PCN-20180911 TE0714-02-* -2IC6 SPI Flash Change

Company	Trenz Electronic GmbH
PCN Number	PCN-20180911
Title	PCN-20180911 TE0714-02-* -2IC6 SPI Flash Change
Subject	BOM change
Issue Date	2018-09-11

This change affects Trenz Electronic TE0714-02 SoMs: TE0714-02-* -2IC6.

#1 Change SPI Flash from N25Q128A11ESE40G to MT25QU128ABA1ESE-0SIT

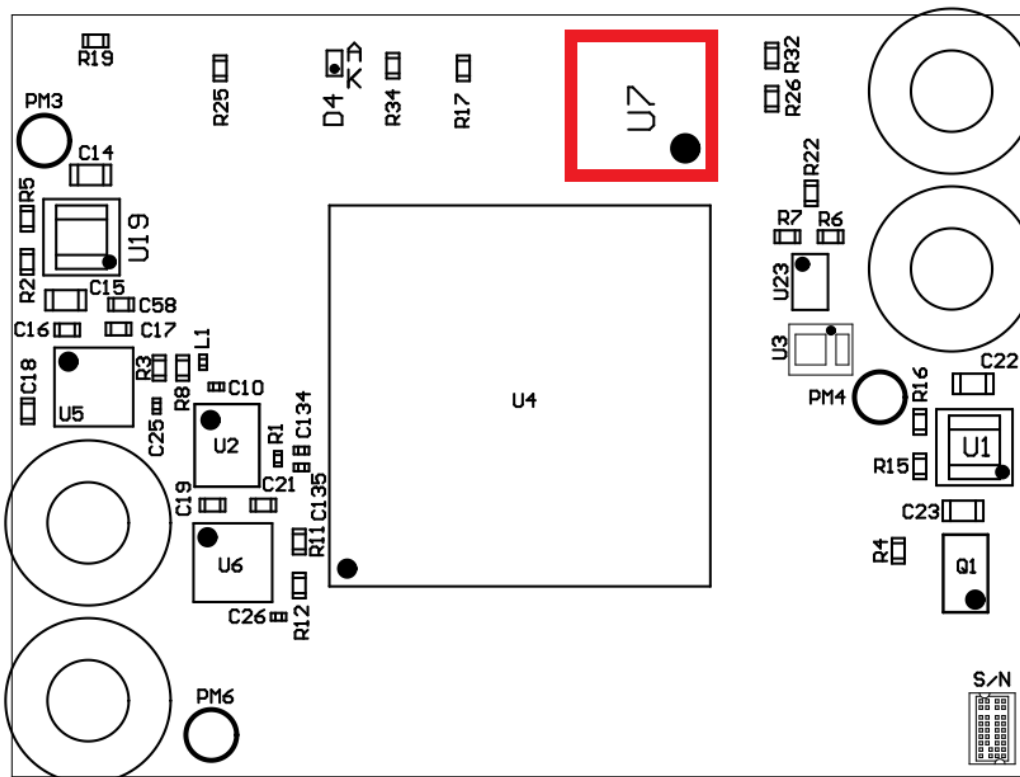
Reason: N25Q128A11ESE40G became obsolete.

Impact: JEDEC ID changed from BB18h to BA18h.

Locate Flash on topside of PCB:

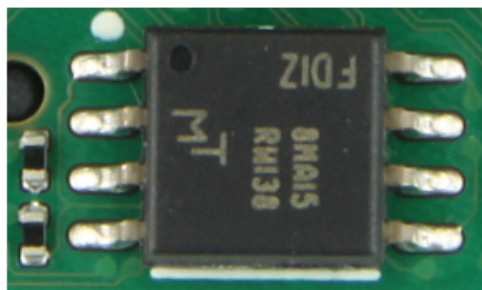
N25Q128A11ESE40G

MT25QU128ABA1ESE-0SIT
